Models 61, 266, 268, 272, 254, 257, 262, 394

New oil tank ventilation tube

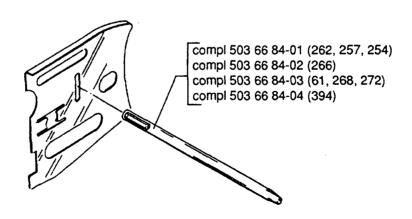
In order to improve the function and to prevent oil leakage, a new design is introduced. The change means that the spiral pin is now mounted inside the plastic tube and then pushed into the crankcase.

New ref. no.	Description	Anm
503 66 84-01	Oil tank ventilation tube compl.	262,257,254
503 66 84-02	Oil tank ventilation tube compl.	266
503 66 84-03	Oil tank ventilation tube compl.	61,268,272
503 66 84-04	Oil tank ventilation tube compl.	394

Oil tank ventilation tube ref. no. 50 18 393-01 and -03 and spiral pin ref. no. 721 42 32-50 remain as spare parts since there is no interchangeability.

NOTE! The spiral pin included in the new design compl. is not the same pin as ref. no. 721 42 32-50.

Introduced from serial number: 61 = 3320001 268 =3320001 272 = 3320001 254 =3320331 257 = 3340001 262 =3310251 394 =3120088
